Type II Site Plan and Environmental Review Staff Report and Decision

Project Name: Union Park Apartments

Case Number: PSR2016-00004; SEP2016-00007

Request: The application requests site plan approval for the construction of a 120-unit apartment complex on 4.87acres in the R-30 zone.

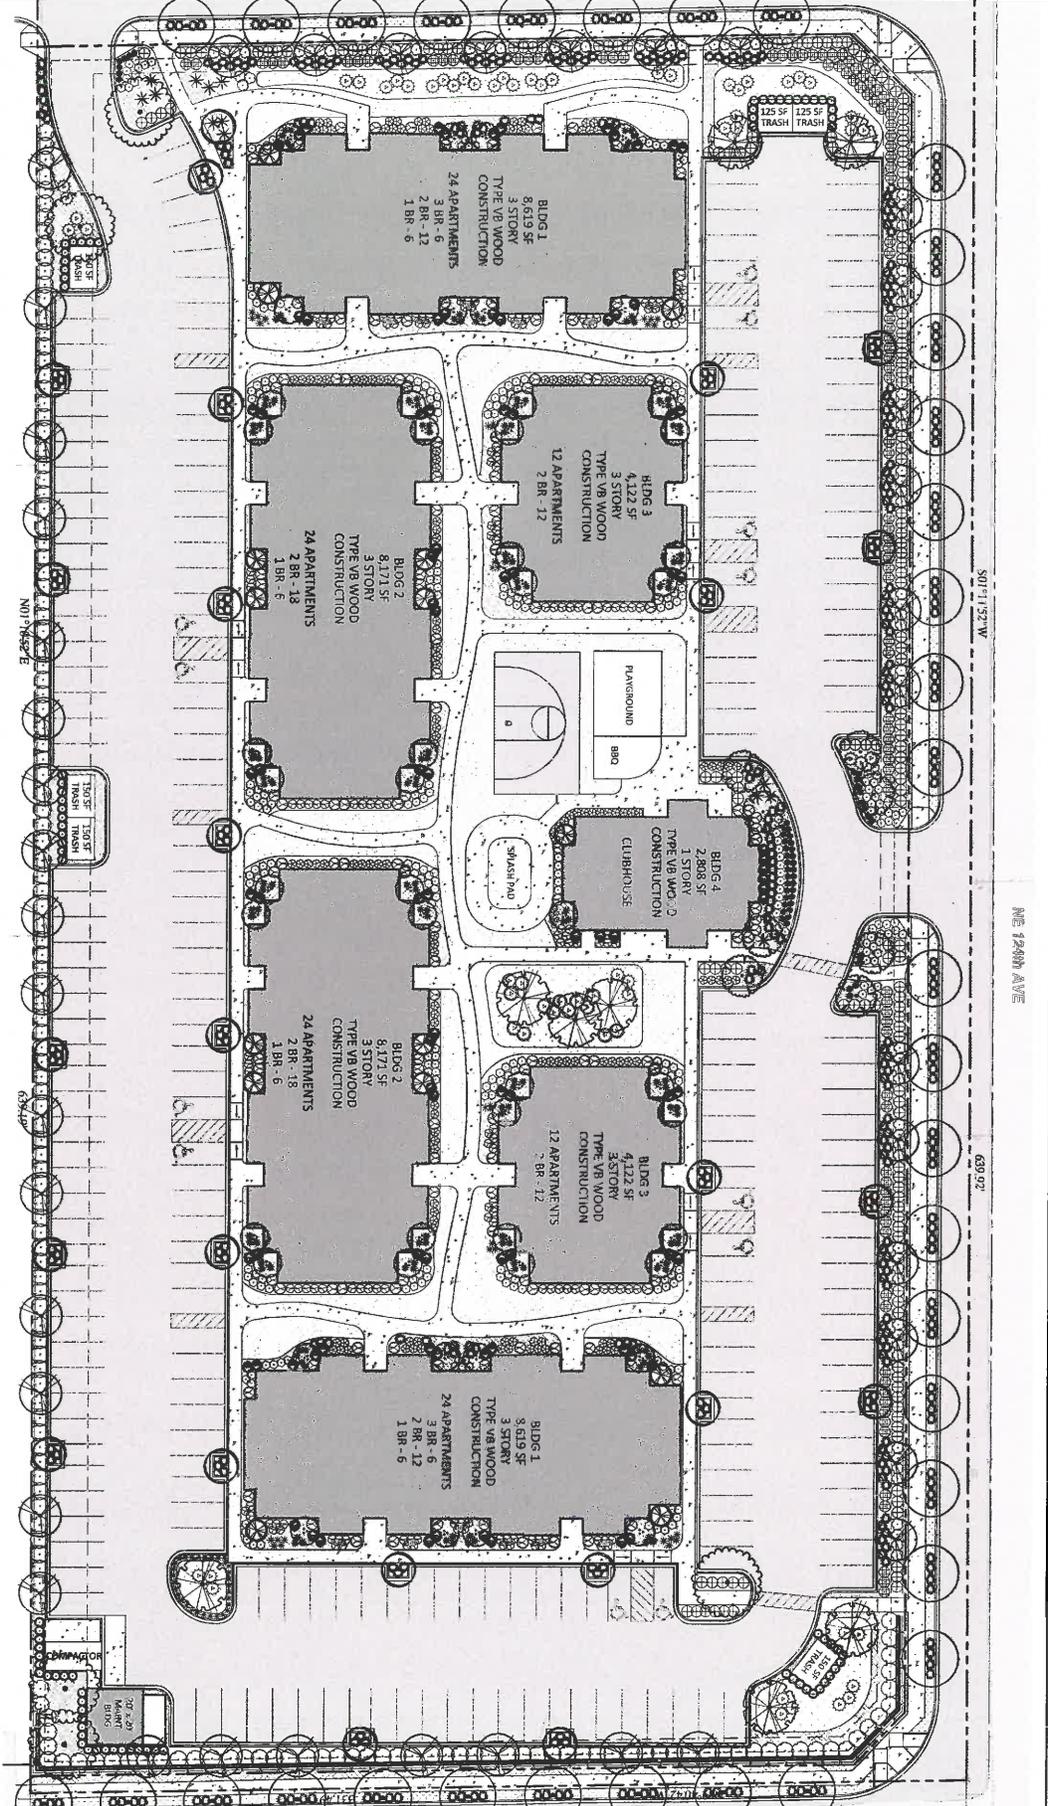
The plans indicate landscape islands (or, the equivalent) that contain a minimum of 45sf but all islands do not include the required tree. The trees shall reach a mature height of thirty (30) feet or more, cast moderate to dense shade in the summer, live at least sixty (60) years, require little maintenance (such as by being insect-, disease- and drought-resistant and not producing fruit), and be suited for use in the proposed location (such as by being tolerant of pollution and direct and reflected heat). Therefore, prior to final site plan approval, the landscape plans shall be revised to indicate one (1) tree in each landscape island, pursuant to Section 40.320.010(E). [See Condition A-2.a]

- a. The landscape plans shall be revised to indicate one (1) tree in each landscape island, pursuant to Section 40.320.010(E). [See Finding 3]
